# Alameda County Fire Department

### Plan Review Comments

<b>To</b>	Miroo Desai, Senior Planner City of Emeryville	<b>PLN #</b>	FDP21-001		
<b>Address</b>	Emeryville Public Market – Parcel A, Parcel B & Parcel F				
<b>Job Description</b>	Review of Preliminary Fire Access Plan				
<b>Reviewed By</b>	Cesar Avila, DFM	<b>Date:</b>	<b>7-27-21</b>	<b>Review #</b>	<b>1</b>

## **Building Division Comments**

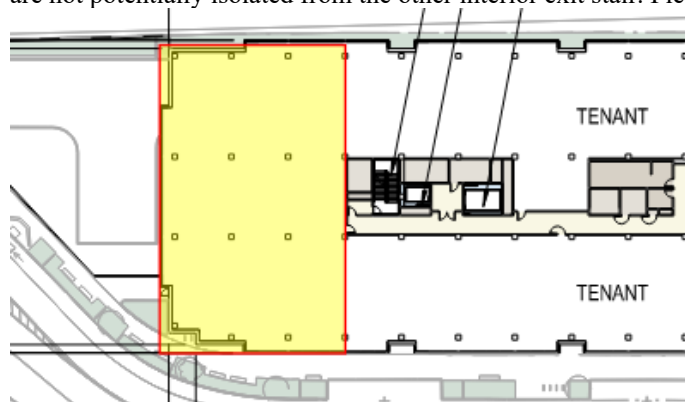
- c. Advisory: The floor area on the North side of the building may be left with access to only 1 exit if only multiple tenant ever occupy a floor. Although this is not a current issue it may arise during tenant improvements. Please consider moving the interior exit stair so large portion of the building are not potentially isolated from the other interior exit stair. Please see image below.
